Work Order ID 98210

Item Name: Replacement Skidtube

DRAWING NO. D2580	TITLE 205 SKIDTUBE ASSEMBLY	REV. E	DART AEROSPACE LTD ENGINEERING ORDER	D.E.O. NO. D2580-E-1	SHEET NO. SHEET 1 OF 1	SCALE NTS
DRAWN <i>UP</i>	CHECKED <i>ASS</i>	MFG. APPR. <i>ER</i>	APPROVED <i>#</i>	DE APPR. <i>#</i>		
DATE 11.12.13	DATE 11.12.13	DATE 11.12.13	DATE 11.12.13	DATE 11.12.13

CHANGE ALL C'BORED WELDED CROSSBOLT SPACERS TO SWAGED SPACERS

SECTION I-I SCALE 5X

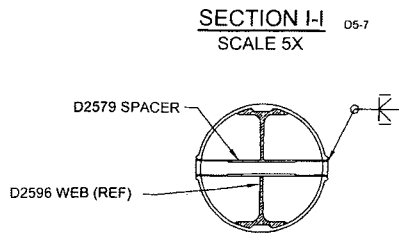
SECTION B-B, SECTION F-F, & SECTION I-I ARE AMENDED AS FOLLOWS
FOR ALL HOLES THAT WERE ORIGINALLY C'BORED:

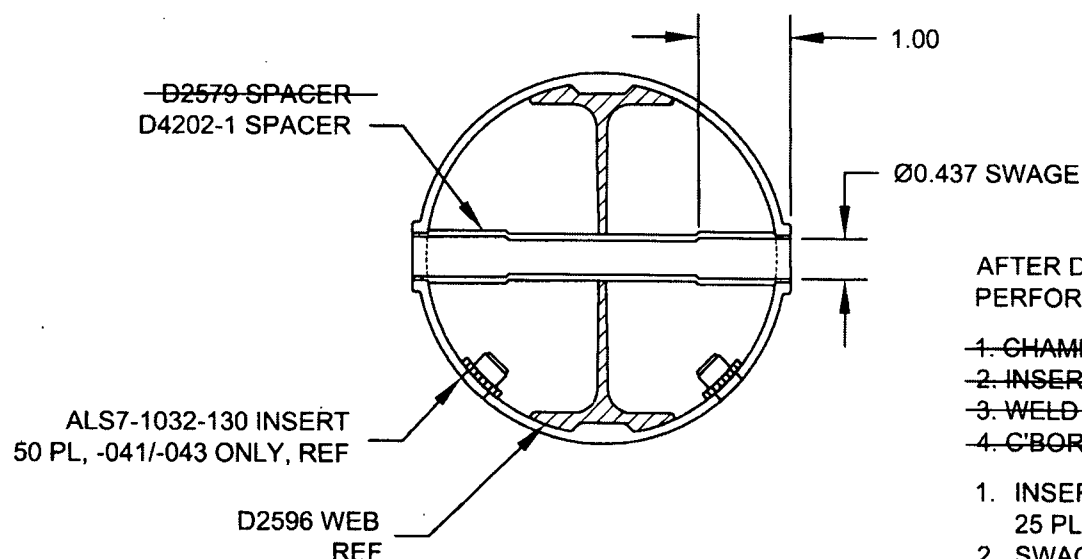
*** FOR -045 SKIDTUBE ONLY:**

WELD 4X D2579 SPACERS PER DWG
IN LOCATIONS MARKED "NO C'BORE".
REF SHEET 4 OF DWG.
